FIGURE 3: Major known active quake faults coincident with, and proximate to, the project site. BHP Billiton LNG's own project map overlaid in red; base map is from U.C./USGS study, 2002. "Beachballs" show locations of only a few representative large quakes.

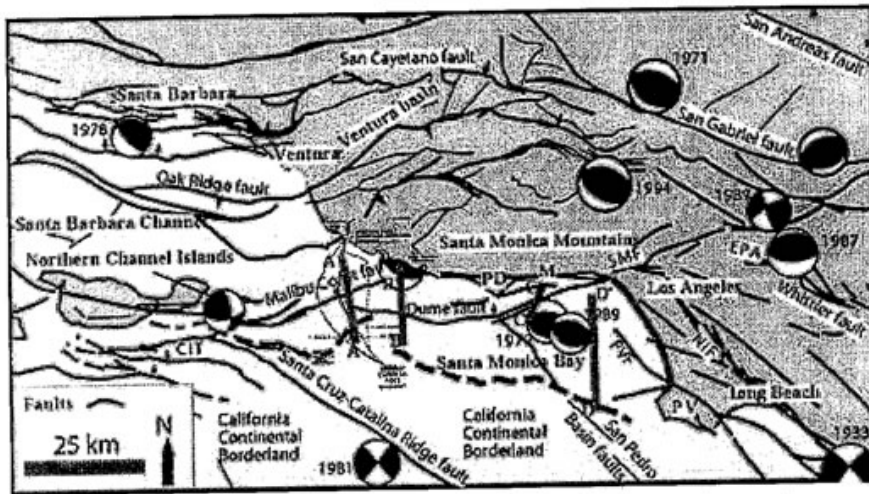
Also omitted is the Santa Cruz-Catalina Ridge Fault, just beyond the Report map's coverage. This fault is situated approximately 7 miles south of the FSRU, and roughly parallels the coastline. (My FIGURE 3.) In 1981, this fault generated a quake in the 6-6.5 range. The Report omits this fault and others by ignoring some recent credible research, notably a 2002 University of California study sponsored by the USGS, "Structure and kinematics along the thrust front of the Transverse Ranges: 3D digital mapping of active faults in Santa Monica Bay using reflection, well, and earthquake data."¹⁶¹ Instead, much of the analysis of seismic characteristics of the area

The UC/USGS study also shows several blind thrust faults in the immediate region of the off-shore pipeline (dotted lines in FIGURE 3), that are ignored in the Report. Blind thrust faults are especially significant in that, whereas they tend to release energy less frequently than surface faults, they do so with *greater* destructive energy.

Tables 4.11-1 and 4.11-2 list the Santa Cruz-Catalina Escarpment as the fault associated with a magnitude 5.9 earthquake in 1981. The fault is shown as #25 on Table 4.11-2 and Figure 4.11-7.

The faults shown in the EIS/EIR maps are major active faults collected from several sources. A blind fault simply means that the fault does not reach the land surface, though it may cause uplift. Table 4.11-2 lists the recorded earthquakes with magnitudes greater than 5.5 within 25 miles or large quakes within approximately 80 miles of the Project. The Northridge Fault is a blind thrust fault. The 1994 Northridge Quake was not as strong as many other quakes that occurred in the area. Therefore, blind thrust faults are not necessarily more destructive than other faults.
